RE: ENFIELD INTERMODAL LOGISTICS CENTRE MODIFICATION REQUEST NO.6

Enfield Intermodal Logistics Centre, Modification Request (MP 05_0147 MOD 6)

Attachment 2: Design Layout - Landscape (from Environmental Assessment (SKM) which forms part of terms of approval' in 5/9/07 Project Approval)

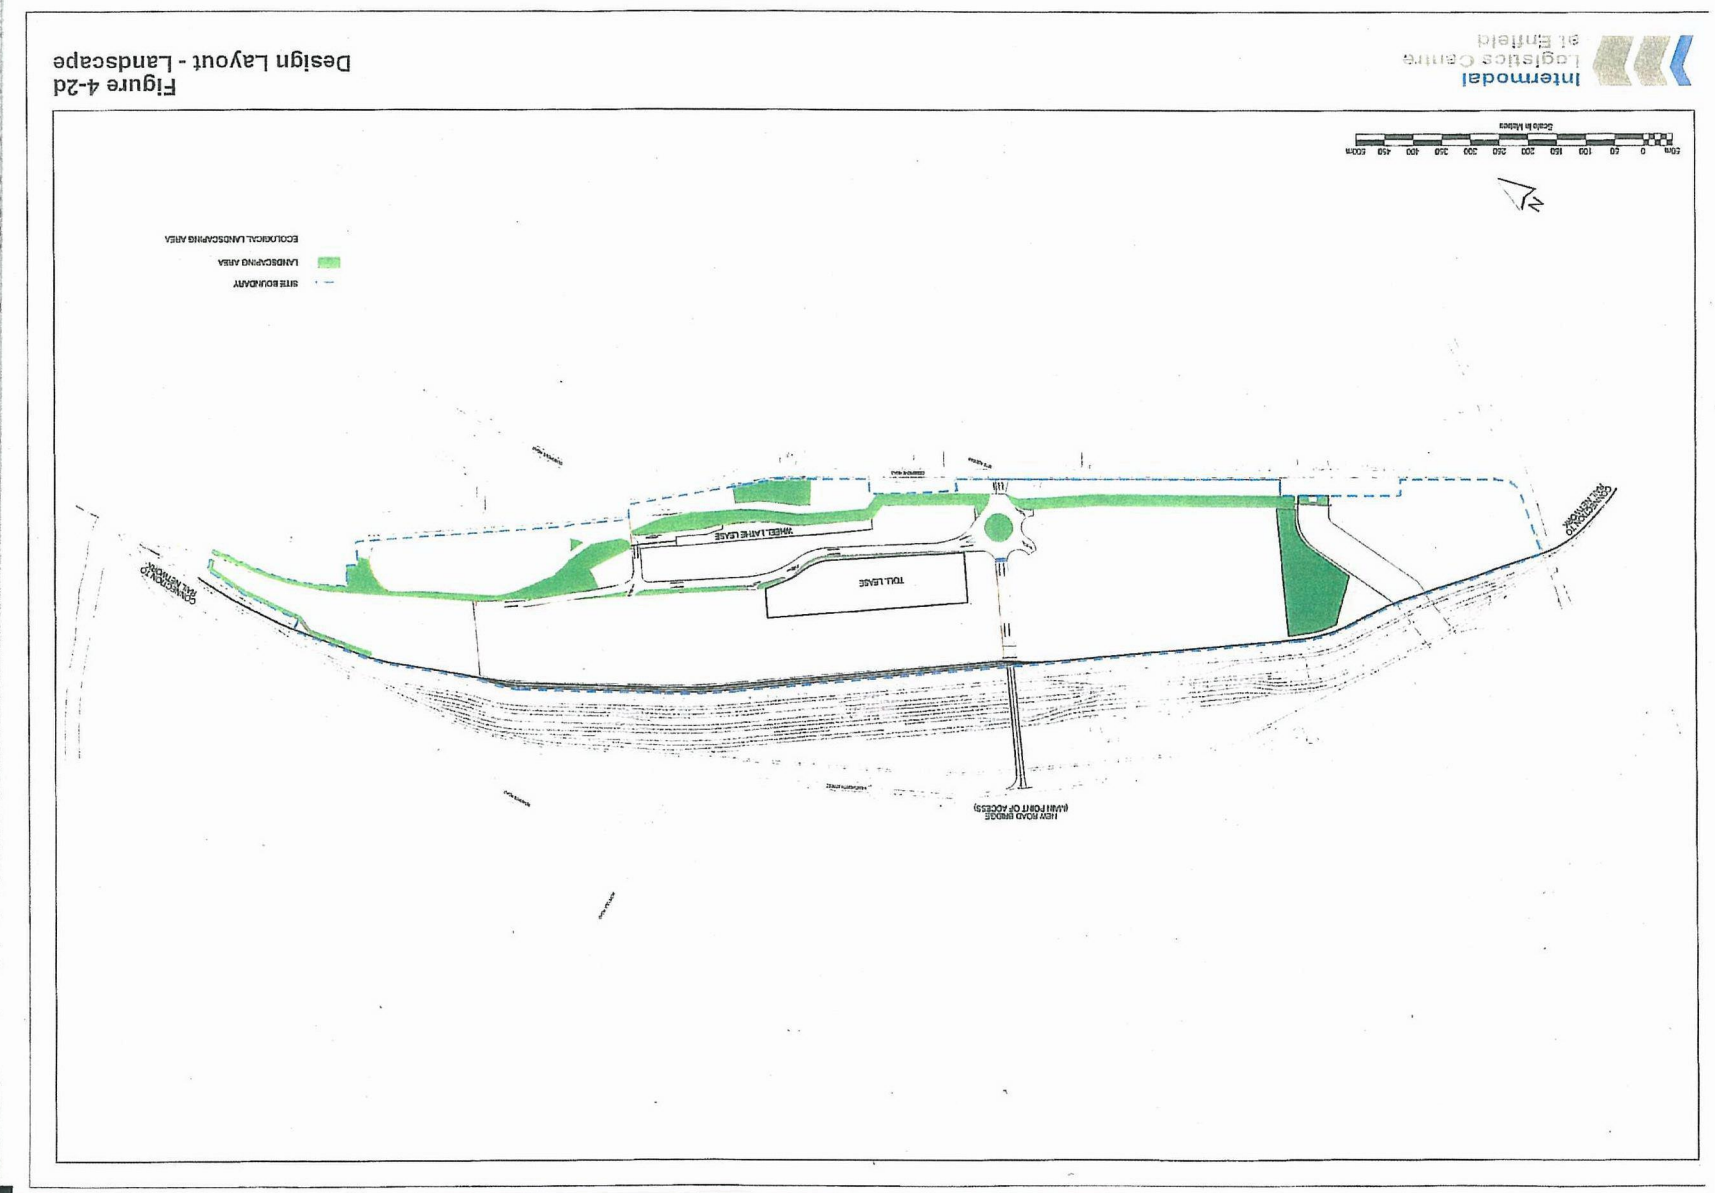
For instance Attachment 2 and Attachment 3 clearly indicate the amount of landscape area across the site (not including the 'Community and Ecological Area') in accordance with the Project Approval. However the gradual reduction in general landscape area is evident in Attachment 4 which appears to be as a result of Modification request No 1 & 2.

Attachment 4: Concept Layout Design (from Sydney Ports Presentation, Jan 2010 - subsequent to Modification 1 & 2)

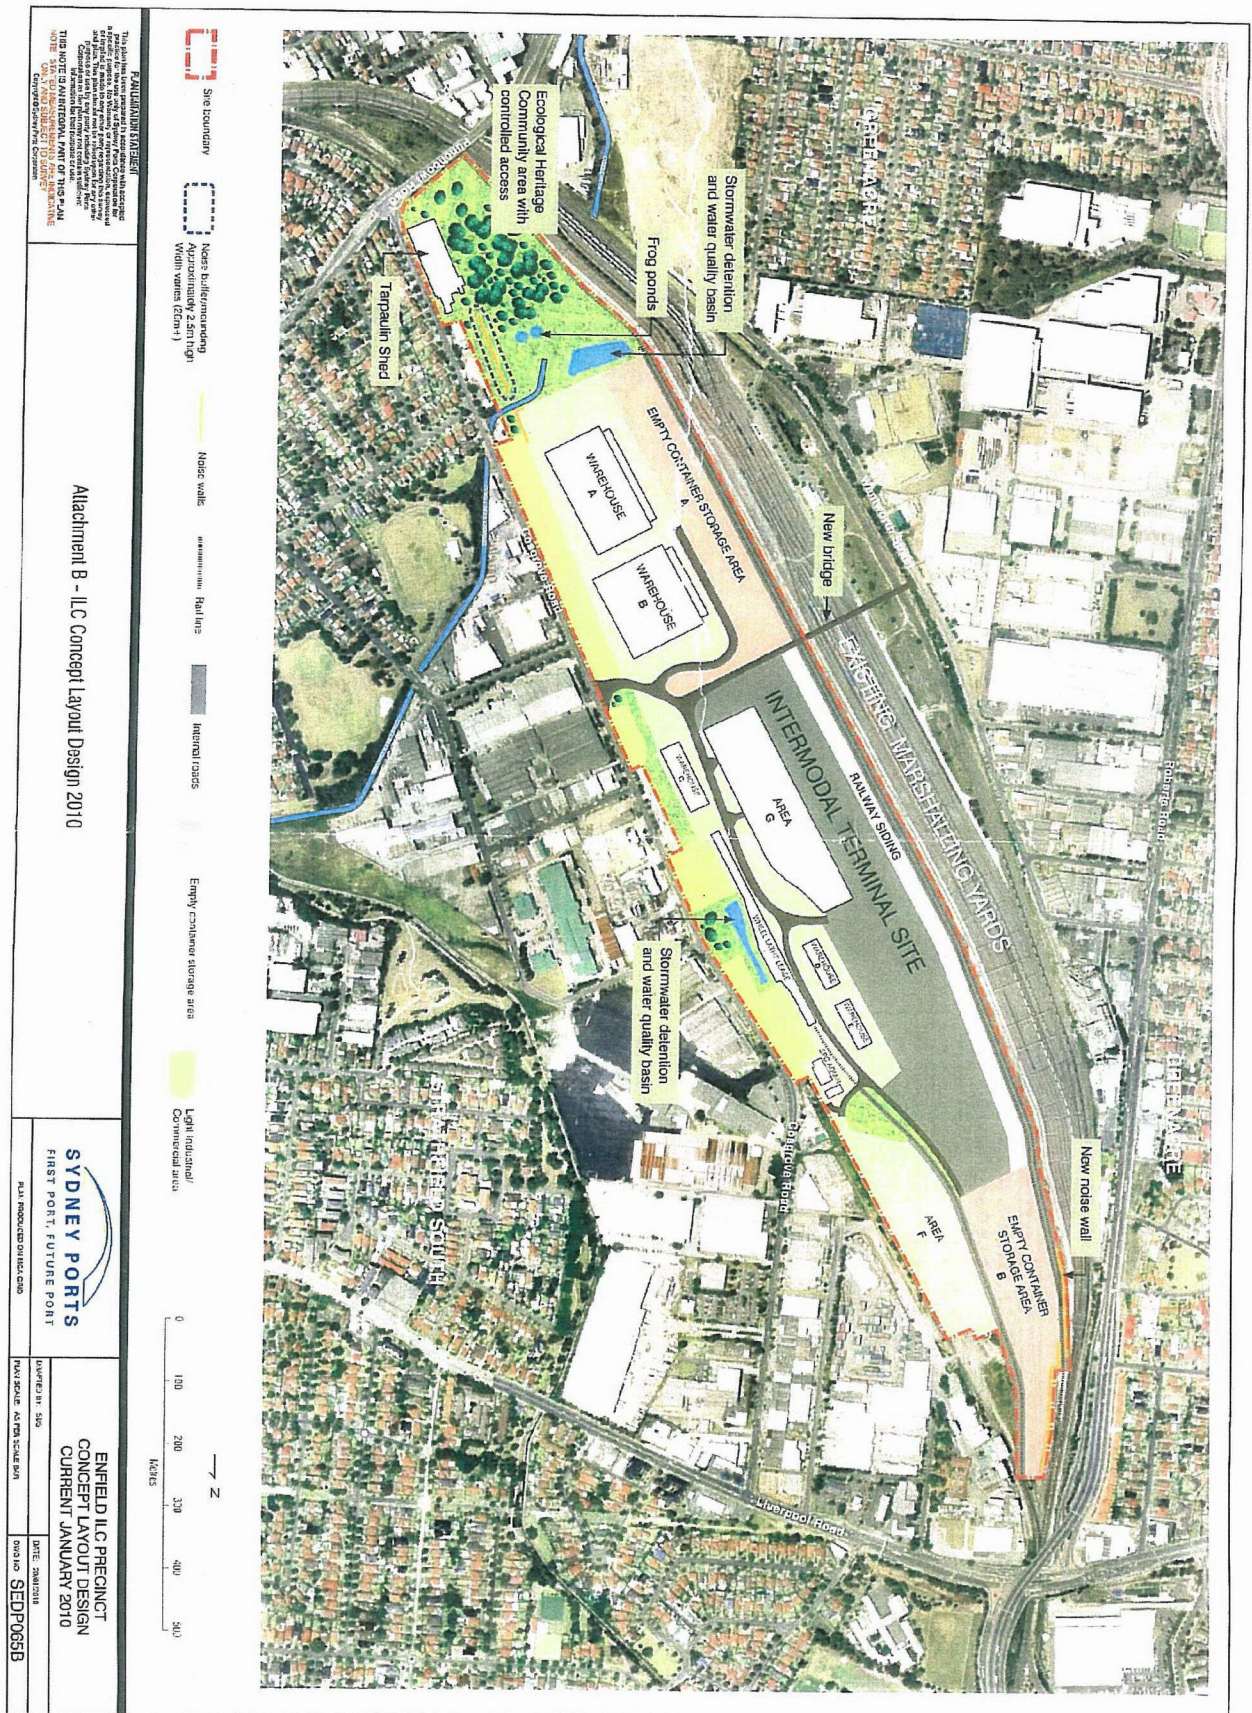
The 'Community and Ecological Area' is also clearly labelled and indicated in green colour on the 'Layout and Key Features' Plan (refer Attachment 3) which was prepared by Sydney Ports some time prior to the Modification No 1 approval. Whilst the January 2010 'Concept Layout Plan' (refer attachment 4) which was prepared subsequent to Modification No 1 & 2 also clearly labels and indicates in green colour the 'Ecological Heritage Community area with controlled access'.

PLAN OF PROPOSED SUBDIVISION OF THE
INTERMODAL LOGISTICS CENTRE
COSGROVE ROAD, ENFIELD

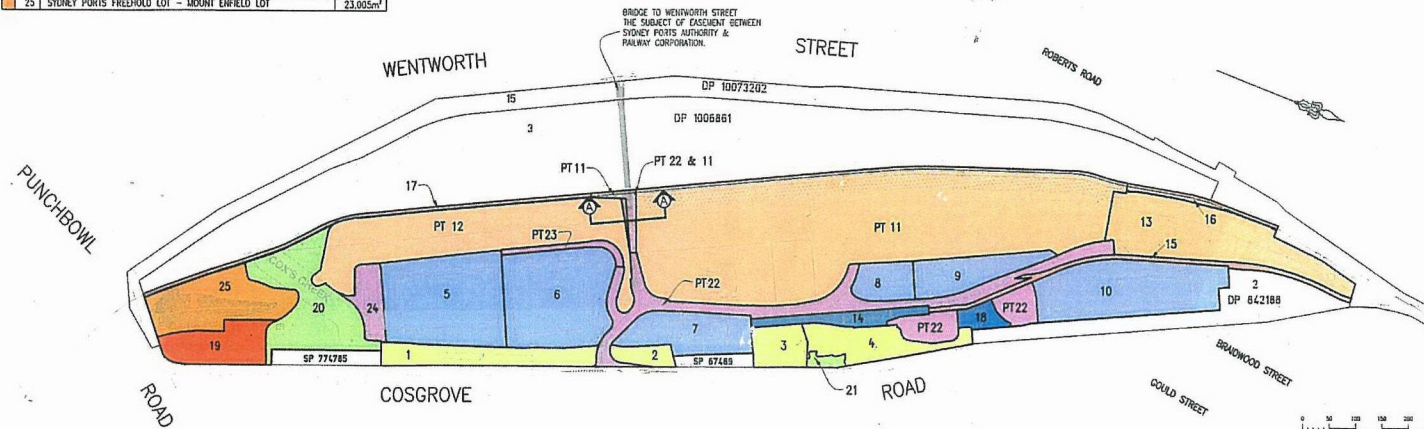
1. The proposed subdivision pattern (refer Attachment 6) conflicts with the intent of the original approval for the southern section of the site becoming a 'Community, Heritage and Ecological Area'. The subdivision plan proposes to subdivide the 'Ecological & Community and Heritage Area' into three lots being: Lots 19, 20 and 25. There is no advantage or logical justification provided in the modification request to divide up the 'Ecological & Community and Heritage Area' which is a key component of the original Project Approval. Subdividing Lot 19, 20 and 25 undermines the preservation of this area especially as it creates potential opportunity for the sale or leasing, particularly of Lot 19 which includes the area at the corner of Punchbowl Road and the Tarpaulin Factory.

The subdivision that creates Lots 19, 20 and 25 is a considerable change that is not supported by Council because it potentially diminishes the amount of land originally dedicated in the original approval for community, ecological and heritage purposes. This precinct should be protected by retaining the land to the southern side of Cocks Creek as one lot. Operational issues for this area such as controlled access to the frog habitat and to the steeper areas of Mt Enfield and whether the Tarpaulin Factory remains on site or is relocated, do not impact on preserving this whole area as a 'Ecological & Community and Heritage Area'.

2. The gradual reduction in the general landscape area across the Enfield ILC, particularly along the eastern side of the site facing Cosgrove Road as outlined above under the Site Layout Changes section is a serious concern. The subdivision of the sites to the eastern section of the site limits the areas dedicated to general landscaping to Lot 21 (other than the Community & Ecological Area south of Cocks Creek) which is not an acceptable amount. Therefore Council does not support the subdivision layout in the present form unless more areas are dedicated to general landscape area to be more consistent with the original approval.
